Conway Planning Commission  
Staff Report

7:00pm • November 19, 2018 • 810 Parkway Avenue

**REQUEST FOR PRELIMINARY PLAT APPROVAL OF REPLAT OF LOT 4, LEWIS RANCH PHASE 2**

**CITY OF CONWAY PLANNING & DEVELOPMENT DEPARTMENT REVIEW OF LEWIS RANCH PHASE 2, LOT 4 REPLAT**  
 This following lists the items that are reviewed by the Conway Planning Department for the changes and/or additions as required by the Conway Subdivision Ordinance for preliminary plat approval. The numbers appearing in parenthesis after the item indicate the page(s) of the Subdivision Ordinance on which the requirement appears.

# LEWIS RANCH PHASE II LOT 4 REPLAT PRELIMINARY

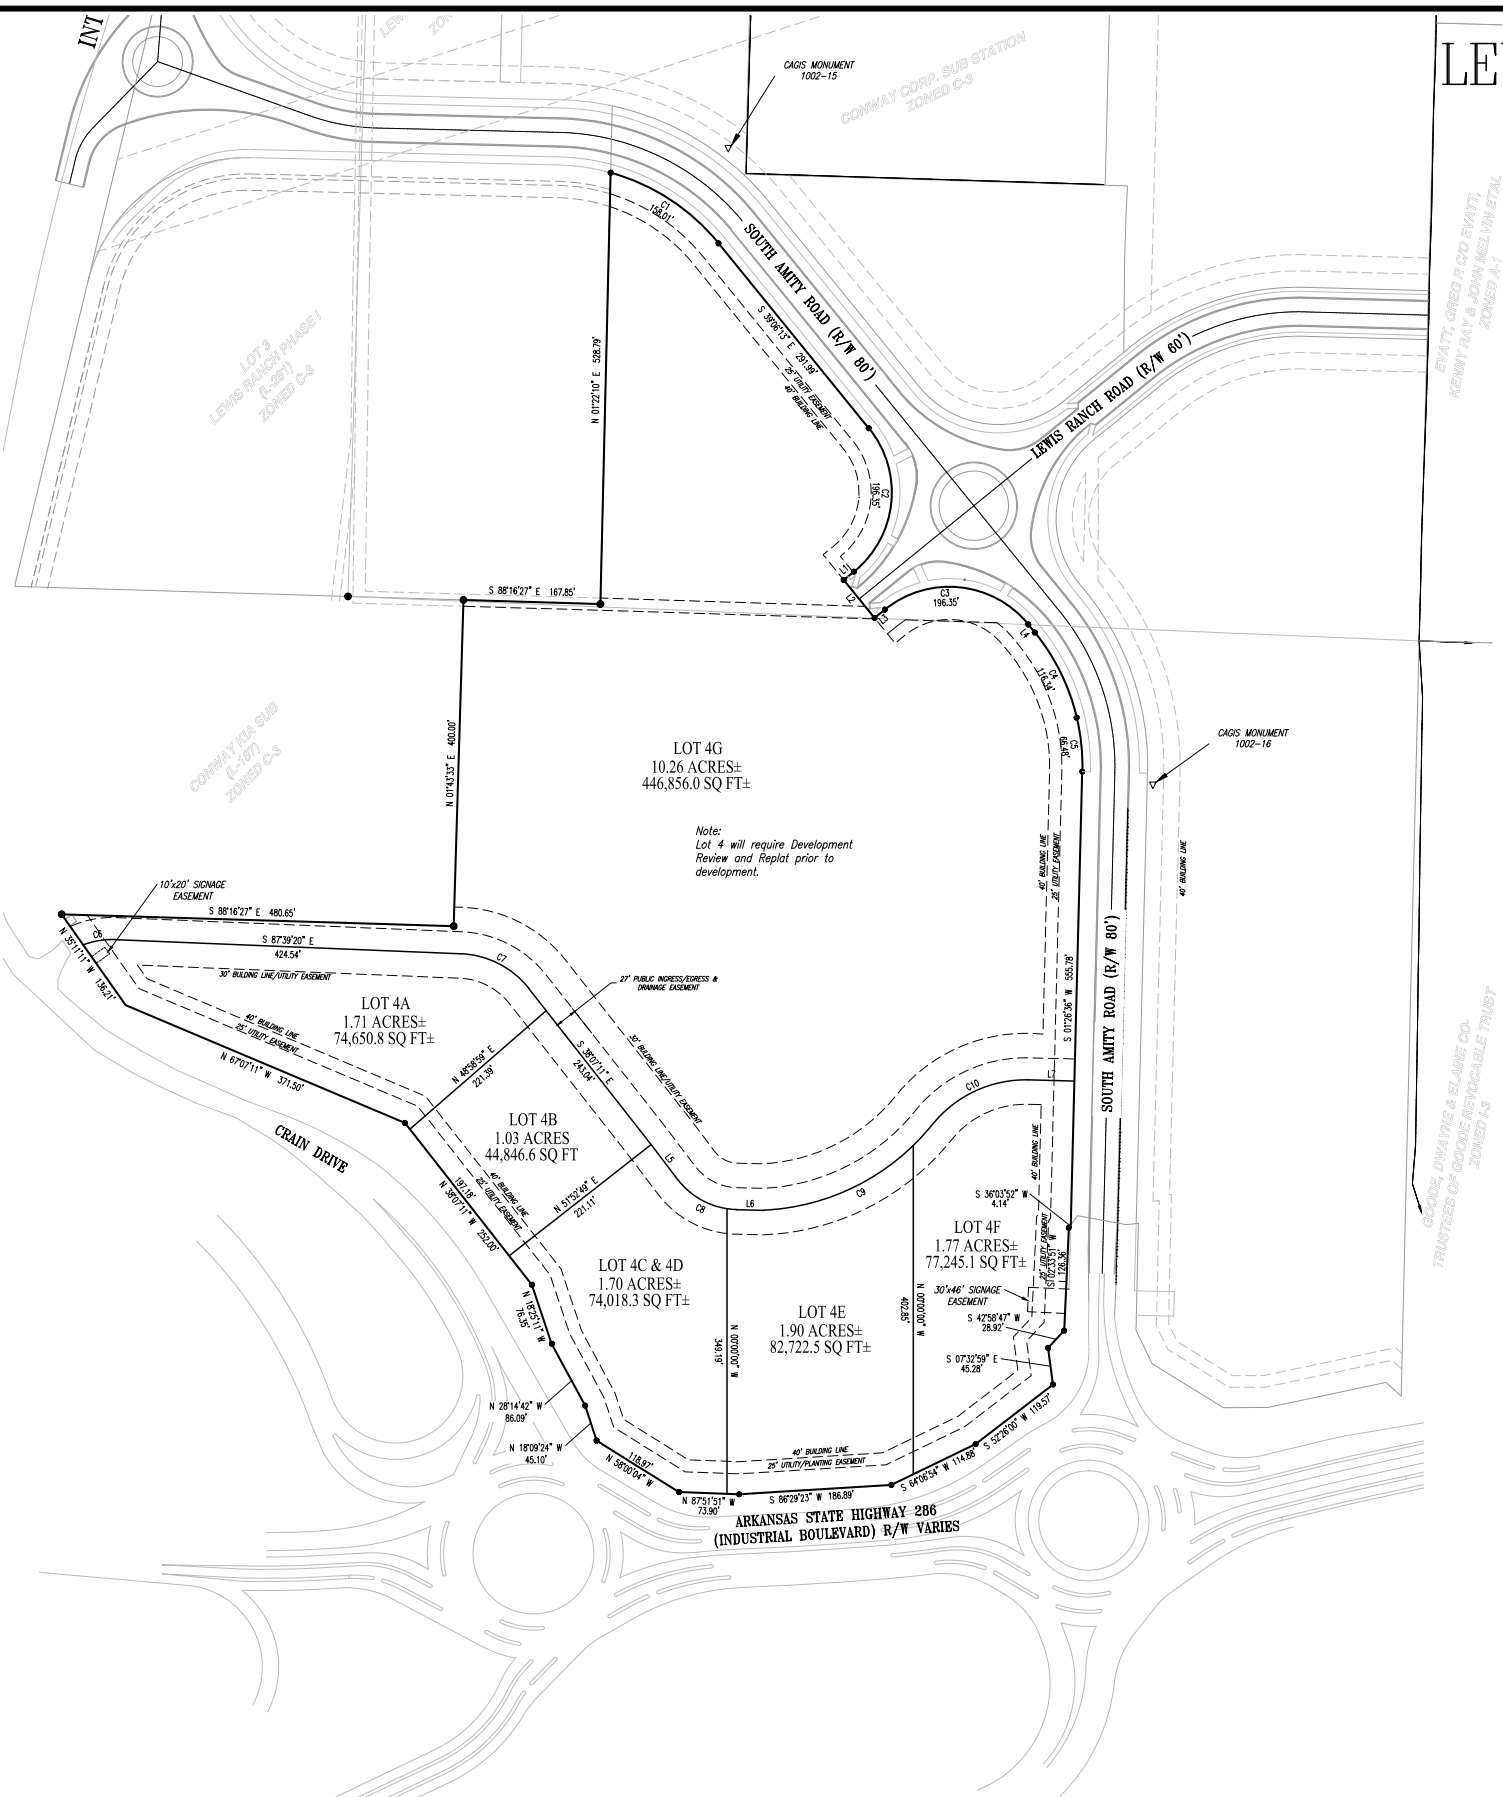
**BASIC INFORMATION NEEDED ON THE PLAT**  
 2. The name of the subdivision/replat is needed. (p. 14)  
 3. A north arrow must be shown.  
 4. The graphic scale must be shown.  
 5. The layout of all proposed sidewalk systems are needed, along with relevant dimensions and bearings.  
 6. Lot lines with appropriate dimensions are needed. *Lot 4C & 4D needs to be changed to one lot number.*  
 7. Proposed easements with appropriate dimensions are needed.  
 8. The source of water supply must be shown.  
 9. The method of disposal of waste water must be shown.

28. Lots must abut upon a public street except where private streets are approved by the Planning Commission in Planned Unit Developments or where a dedicated access easement 25' in width in C-1, C-3 or O-1 has been approved by the Planning Commission. Street frontage width must comply with the Zoning Ordinance requirements. ***Lots 4C, 4E and 4F are restricted access from AR State Hwy 286. Applicant proposes a 27' private street with a public access easement from South Amity Road to Crain Drive. Planning Commission Approves / Does not Approve the dedicated 27' Public Access Easement from South Amity Road to Crain Drive, or this condition must be corrected.***

29. On double frontage lots, a planting screen easement of at least 10 feet shall be provided along the portion of the lot abutting a traffic artery or other use where screening is required. There shall be no right of access across the planting screen easement and such restriction shall be clearly designated on the plat and within any Bill of Assurance. *A 25' planting screen easement is needed along public street frontages of Lots 4C through 4F.*

31. Every lot must slope to a street or to a drainage easement. Add to general notes.

35. Sidewalks are required along both sides of all streets within all zoning districts within Conway city limits and within the Conway Territorial Jurisdiction. *Existing and Proposed Sidewalk location and responsibility for construction is needed on the plat for all lots along South Amity Road, AR State Hwy 286 and Crain Drive.*

37. When a developer created double frontage lots with one side along a street classified as a collector or above, the developer shall construct sidewalks along the collector or greater street frontage. *Developer is required to construct sidewalks along Crain Drive for Lot 4A and South Amity Road for Lots 4F.*

**STAFF RECOMMENDATIONS**  
 Planning Staff recommends approval of the preliminary plat contingent upon the completion of the amended punch list.
